**Manor Road / Richmond**  
Design & Access Statement Landscape  
Addendum 02

## 1.0 Landscape Addendum

Project number	P11559-00-001
Project title	MANOR ROAD
Document title	LANDSCAPE ADDENDUM
Client	AVANTON RICHMOND
Document status	Revision 01
Date of issue	24 July 2020

DETAIL OF BUS LAYBY- AMENDED PROPOSED DEVELOPMENT

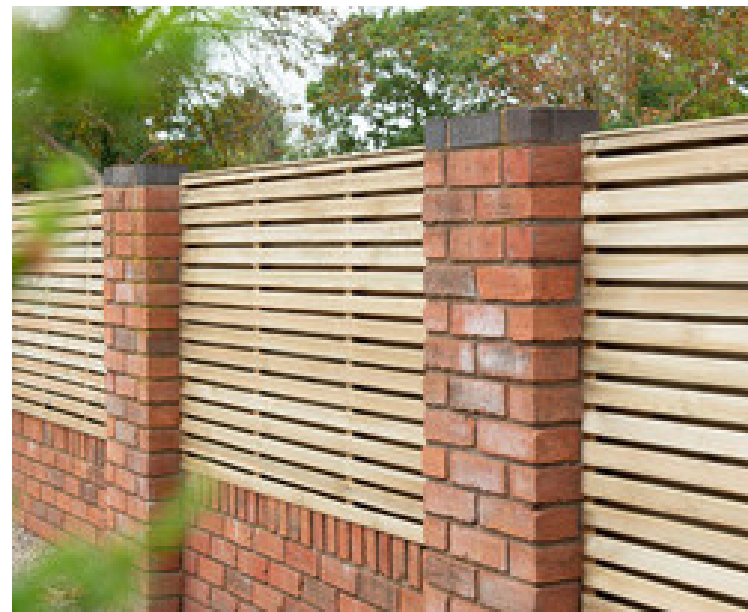
The removal of Block E from the scheme allows the existing bus layover area to the northern corner of the site to be retained in its existing location. Buses will use the existing junction to Manor Road with no changes to vehicle movements.

Landscape enhancements to the area are included in the proposals to improve the general appearance of the area and the outlook from adjacent residential units.

Existing trees and planting are retained and reinforced with additional understory planting whilst additional street trees are proposed on the corner of the junction and central island to extend the line of street tree planting from the south and frame the entrance. Planting to the central island will also significantly improve the visual enclosure of the Layby and benefit the outlook from the adjacent residential units.

New infill panels are proposed to the existing brick fence/wall along the Manor Road frontage to increase the height and visual screening benefits of this barrier.

Contrasting paving is also proposed across the junction and to both entrances to the layby area to delineate a change of character from vehicular road and bus area to residential street and to contain the functional area of the layby. Paving within the layby area will be retained as existing.

- 1. Existing trees retained
- 2. Proposed new street tree planting
- 3. Proposed understory planting
- 4. New infill panels to wall
- 5. Contrasting paving to entry points
- 6. Existing paving retained

DETAIL OF MANOR ROAD FRONTAGE- AMENDED DEVELOPMENT

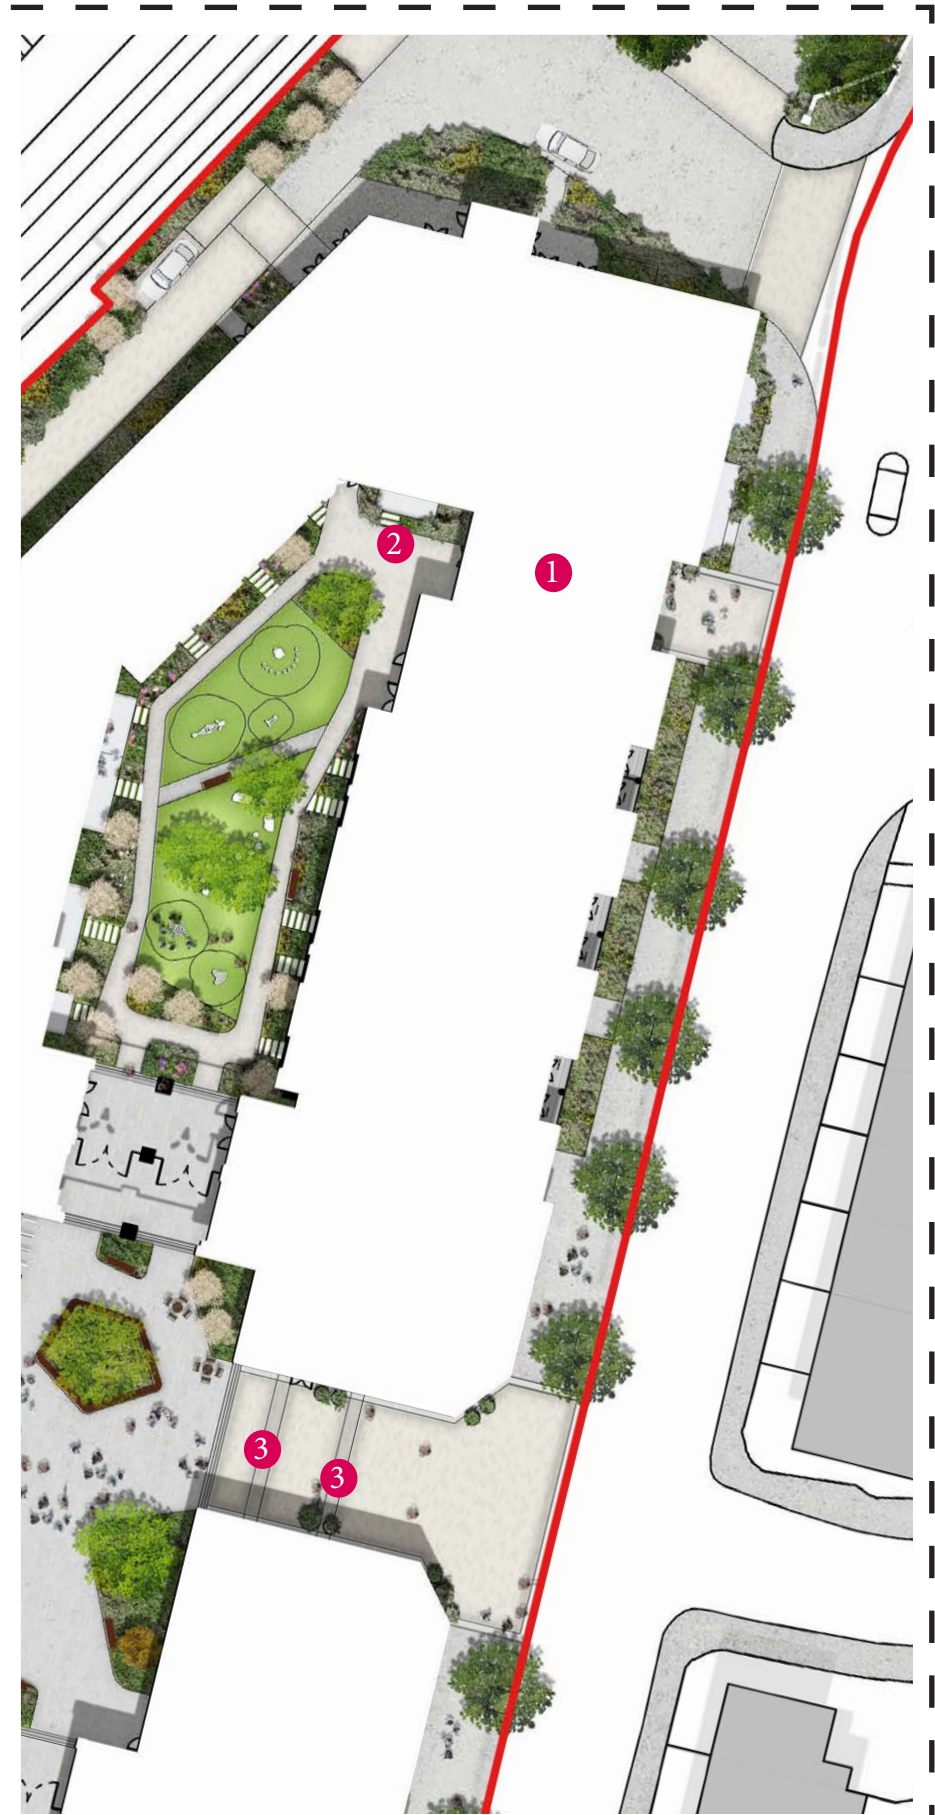
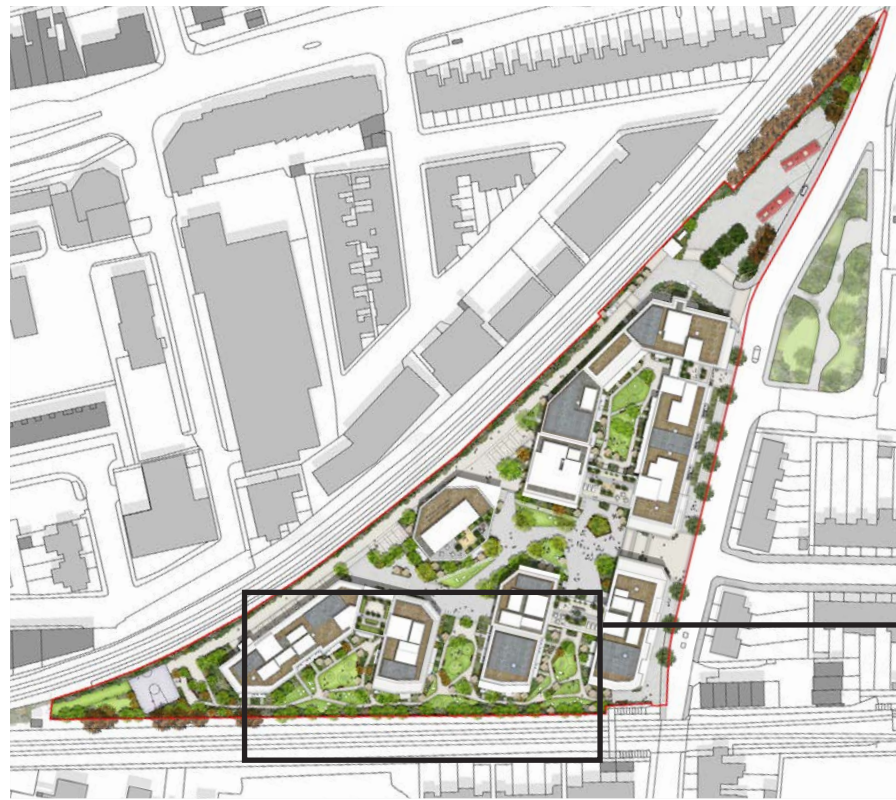
- Concerns were raised about the open passageway from Manor Road to Block A courtyard. This has been replaced with a generous lobby space with landscape design amended to suit.

- Proposed climber planting has been removed from around the main pedestrian entrance from Manor Road in response to MDA comments due to concerns over long term maintenance.

- 1. Alleyway to Block A courtyard removed and replaced with internal lobby space
- 2. Courtyard planting and paths adjusted to suit new lobby layout
- 3. Removal of climber planting from archway

DETAIL OF SOUTHERN COURTYARDS- AMENDED PROPOSED DEVELOPMENT

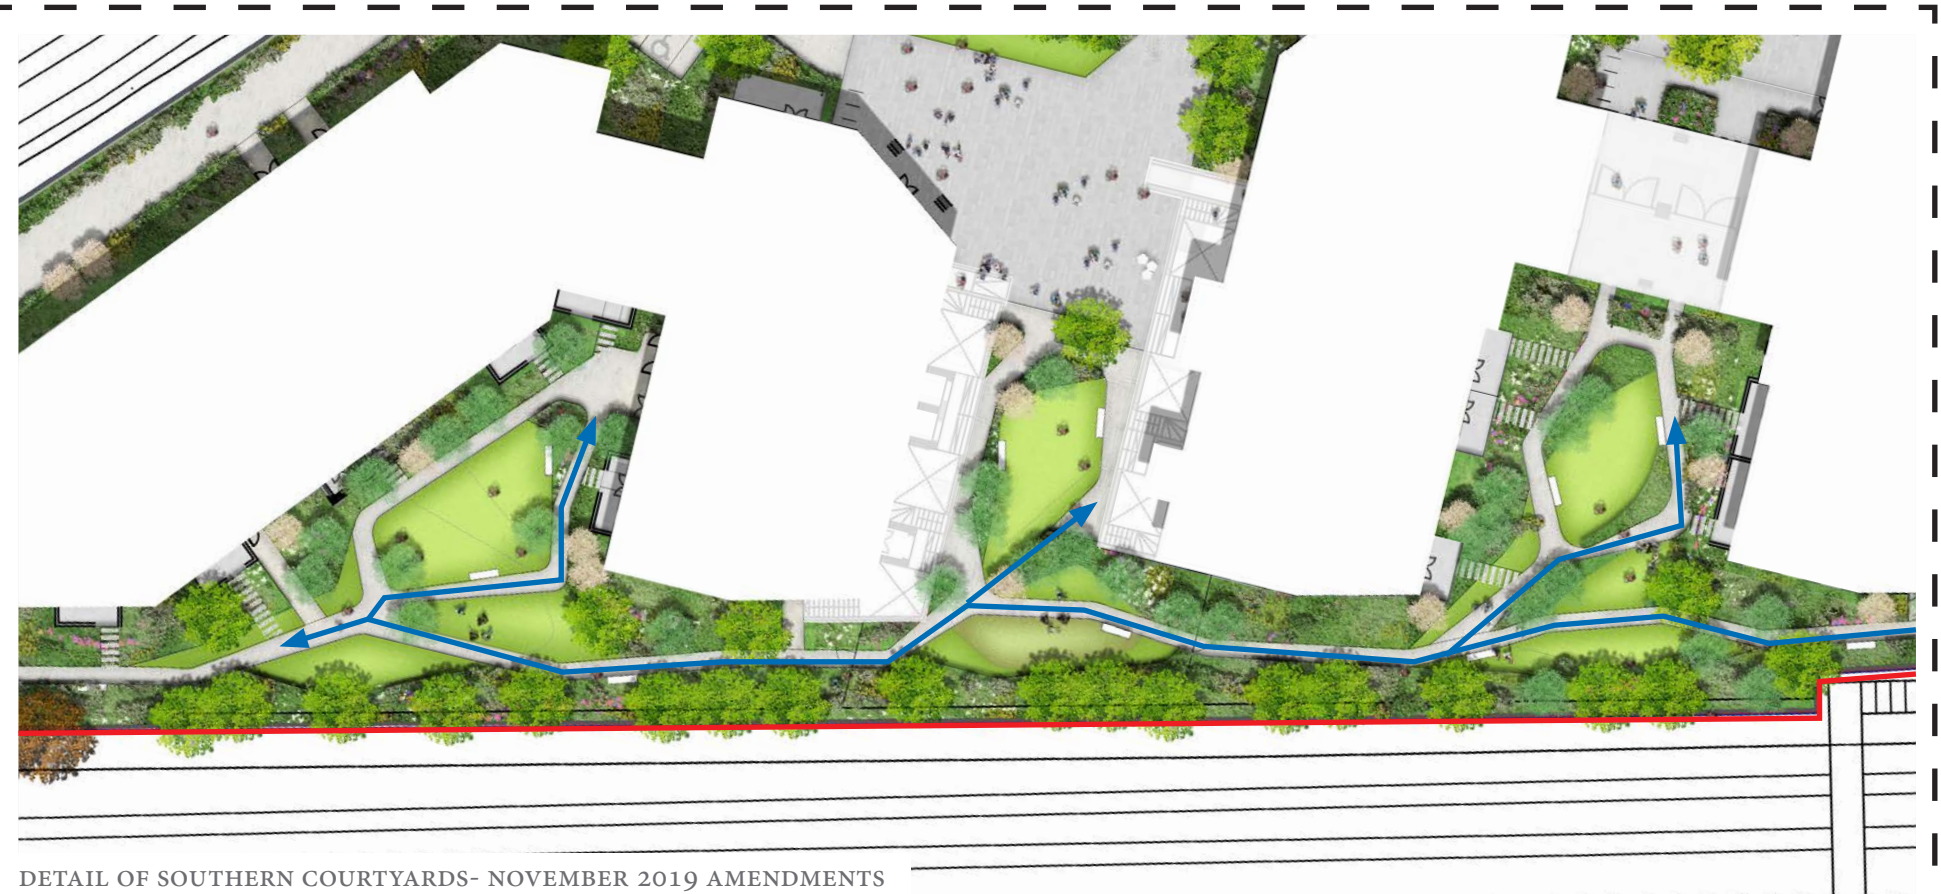
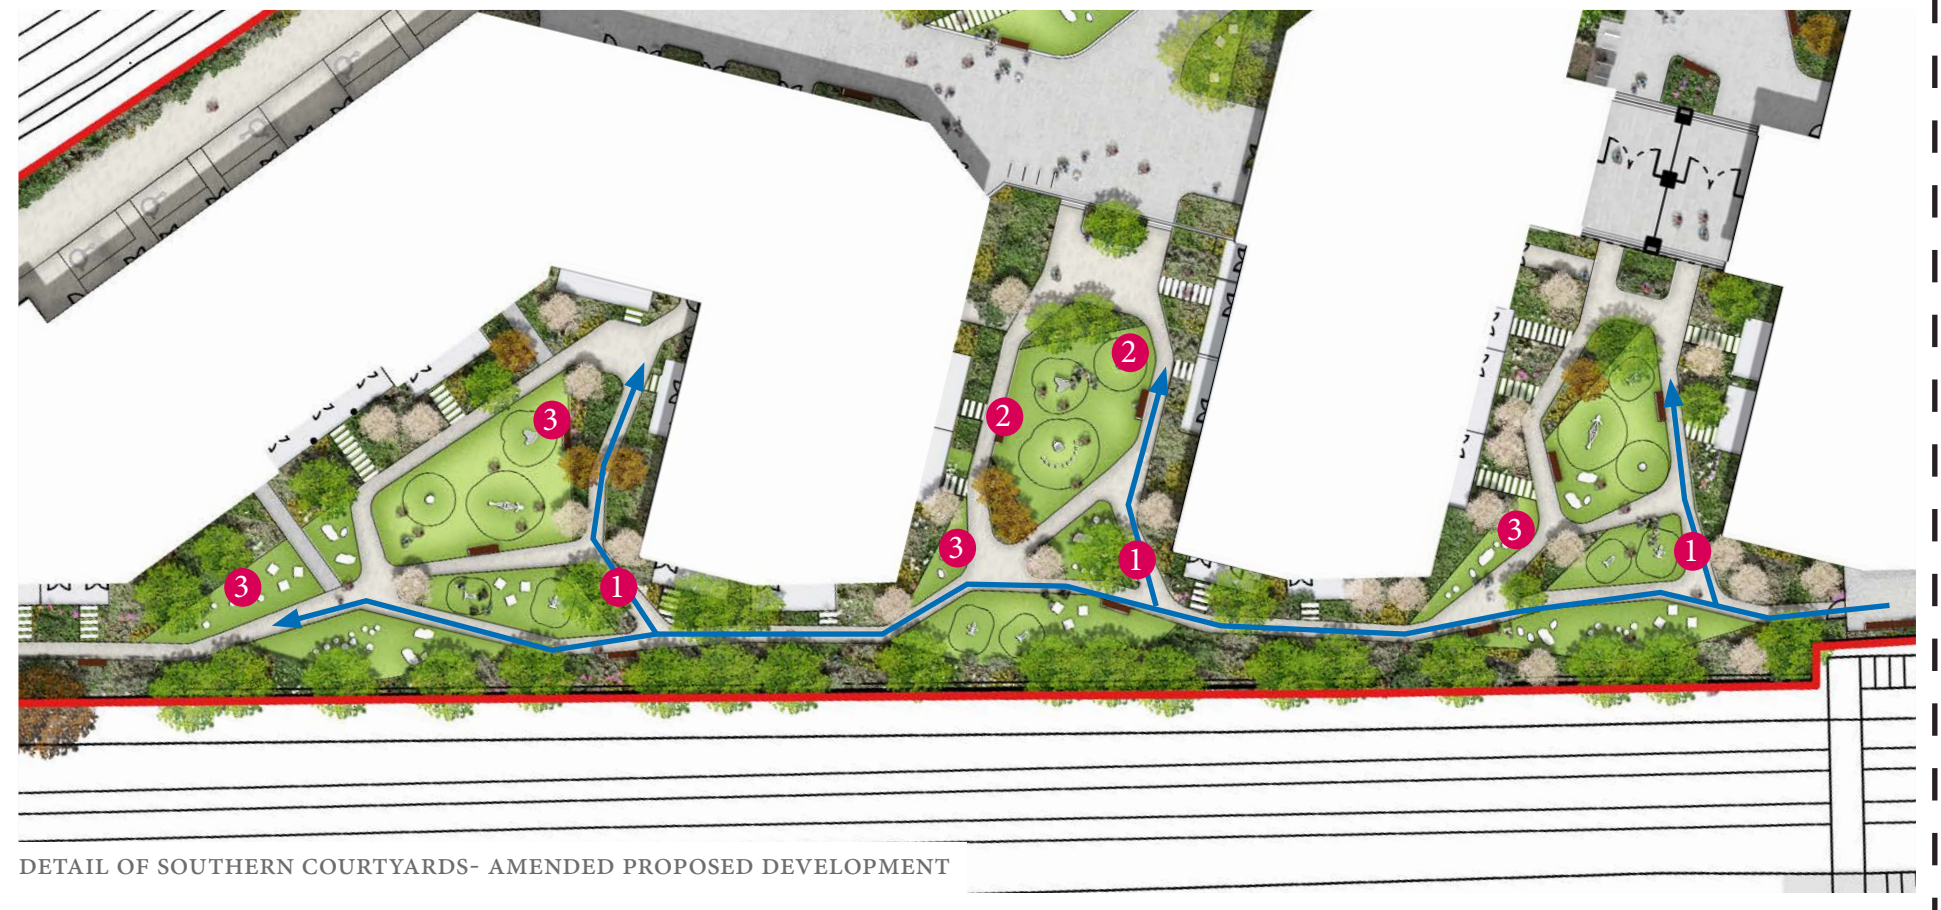
- The path layout within the southern courtyards was questioned, in particular the desire lines to the new entrance in the south eastern corner. Path networks within the courtyards have been rationalised to provide a more coherent route to residential entrances.

- It was suggested that there was scope to add richness to the landscape design, in particular providing more space for residents amenities and play. In response courtyards have been rationalised to maximise the usable space, in particular for provision of residents play space.

- Long term management and maintenance of the landscape has been considered in response to MDA concerns. Alongside rationalisation of courtyard paths and amenity space, planting beds have been reduced in depth to improve maintenance access and the indicative planting palette provides a drought tolerant, low maintenance scheme. Ongoing maintenance of landscape within the private ownership boundary will be the responsibility of the Client or their appointed management company.

1. Rationalisation of path layout
2. Courtyard layout rationalised to optimise amenity space - paths have been shifted closer to the edge of the space to increase central amenity space
3. Planting depth reduced to improve maintenance and provide additional amenity

PARKING STRATEGY PLAN - 3% PROVISION

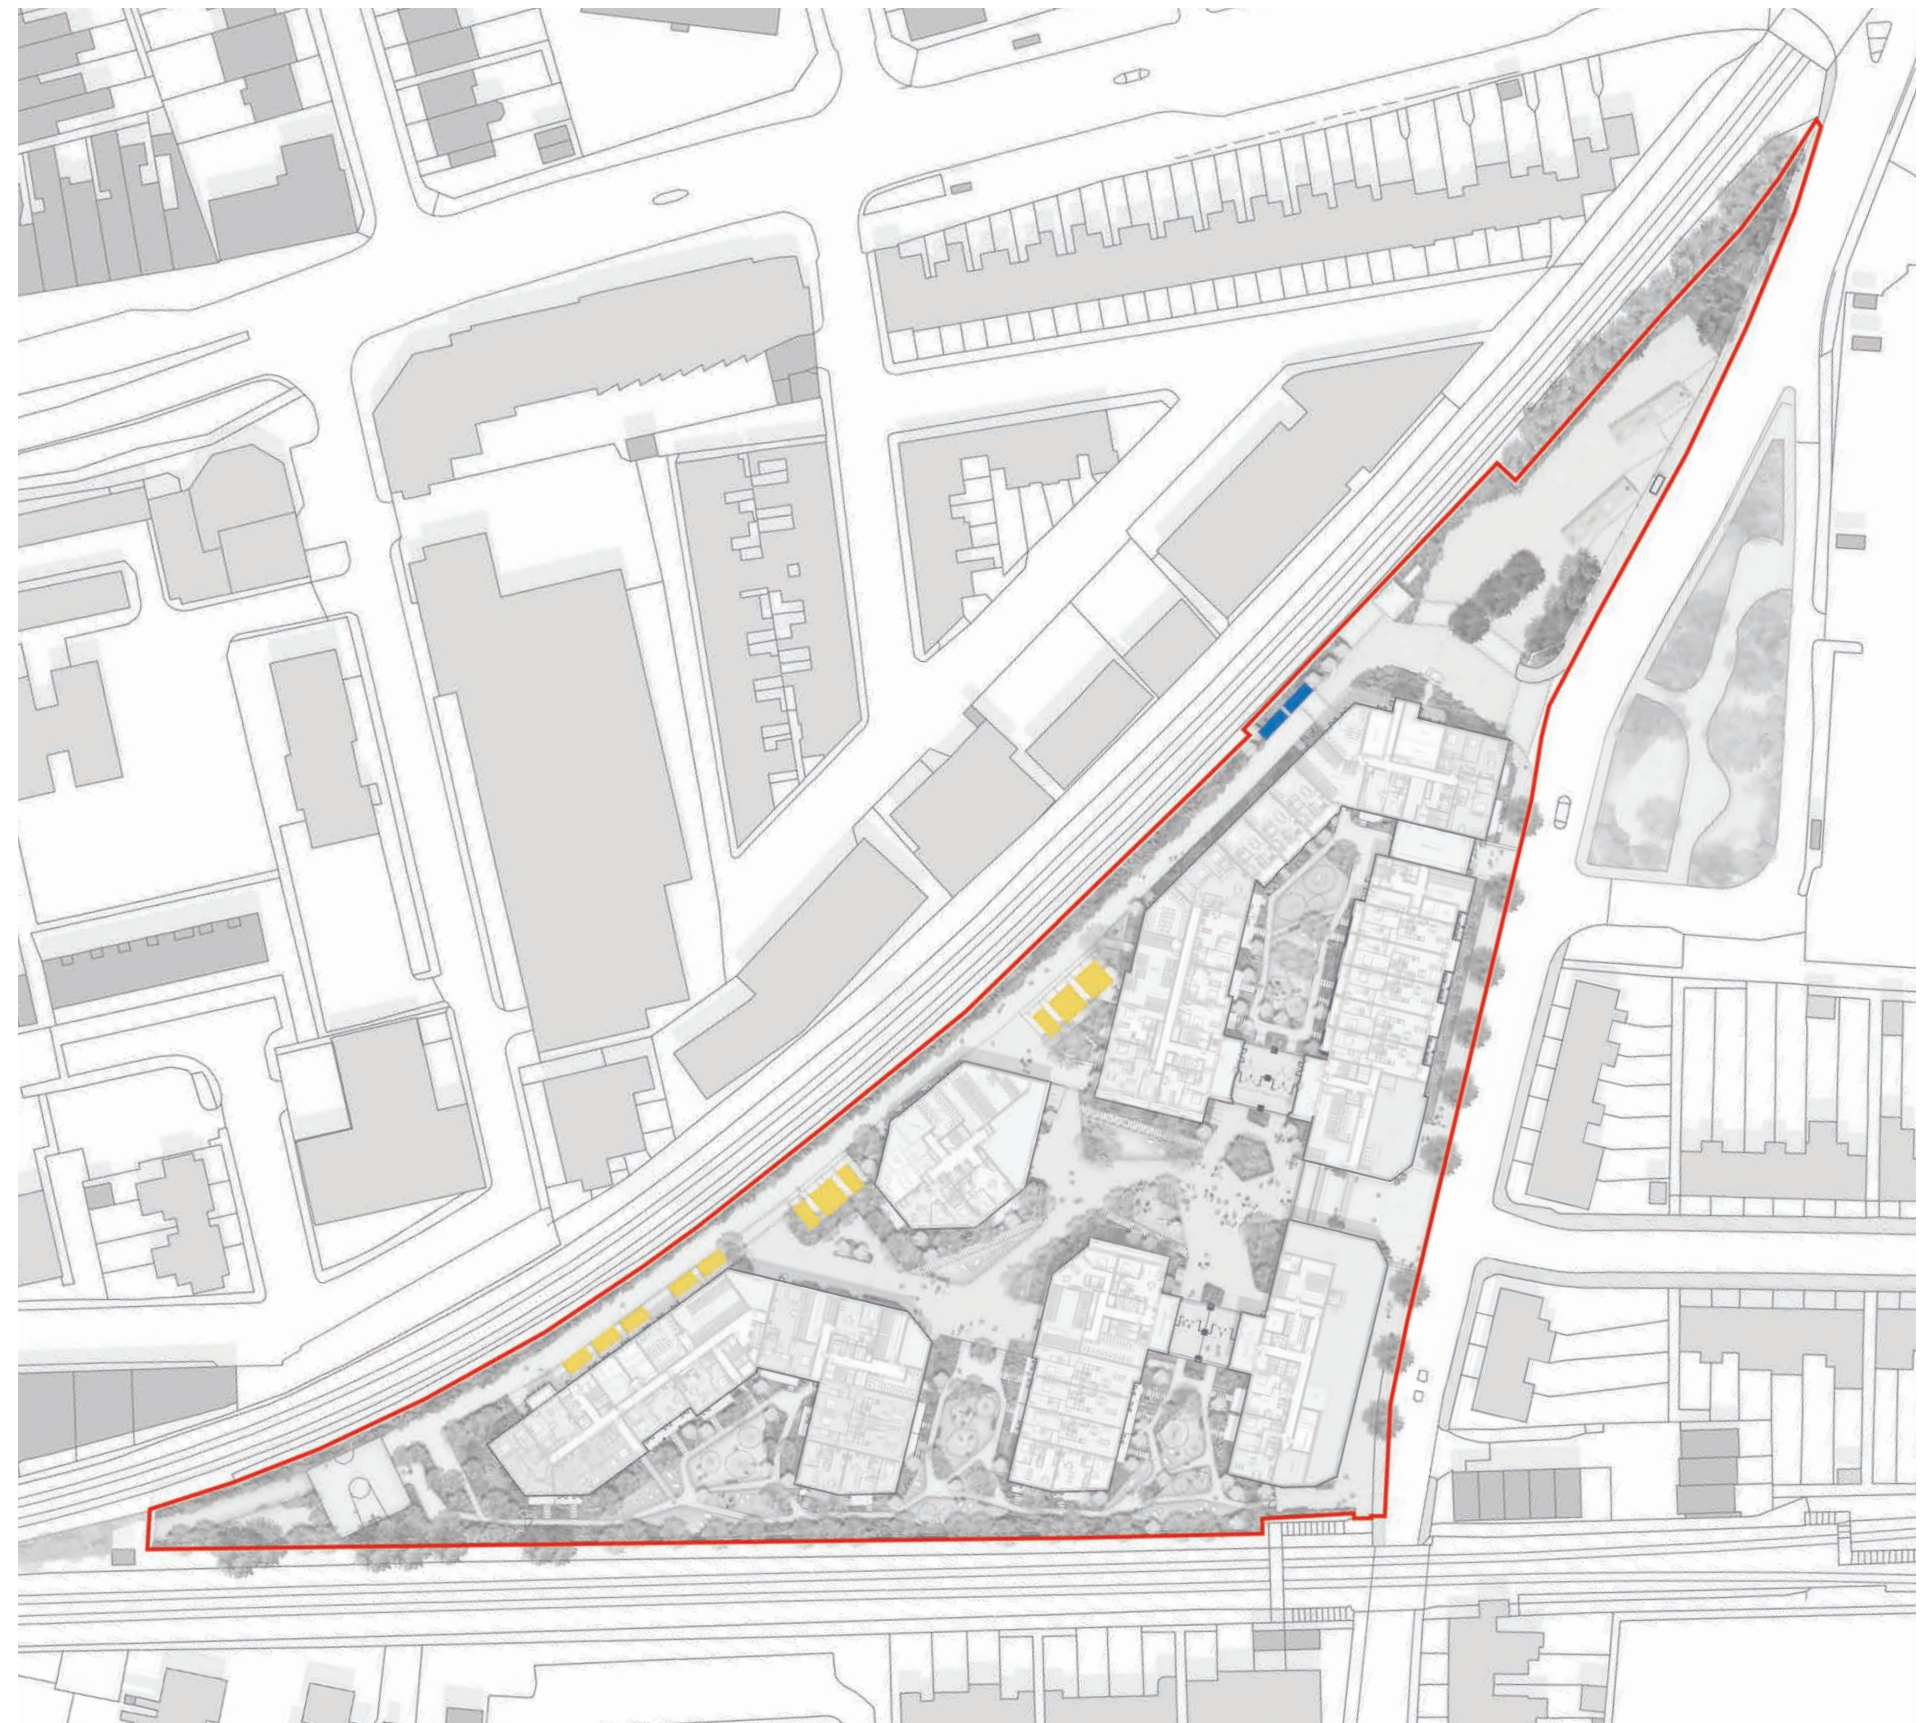
Accessible car parking spaces are provided on site for 3% of units (14 No spaces) to comply with ItP London Plan requirements. These have been increased by 2no. from the November 2019 Amendments.

The location of these bays has moved from the southern edge of the junction to the western boundary following discussions with TFL to avoid potential conflict with manoeuvring buses.
